# ADDENDUM No. 1 August 31, 2016

Subject: Greenwood Township – Thayer Road 16-0900-01-BR September 7, 2016 Letting

#### Clarification to Railpost Spacing:

### EXISTING DECK PLAN

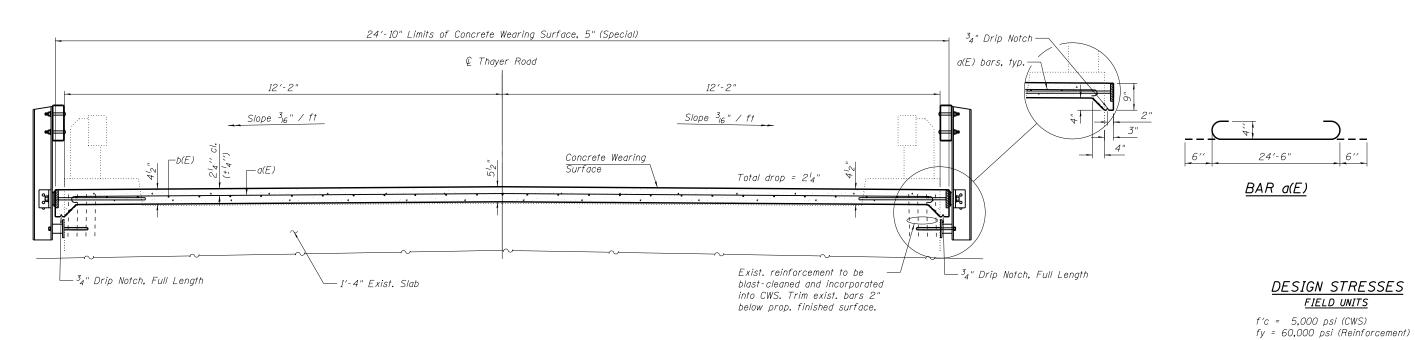
1. Revision is limited to Railpost spacing in plan, upper left of drawing 5 of 6.
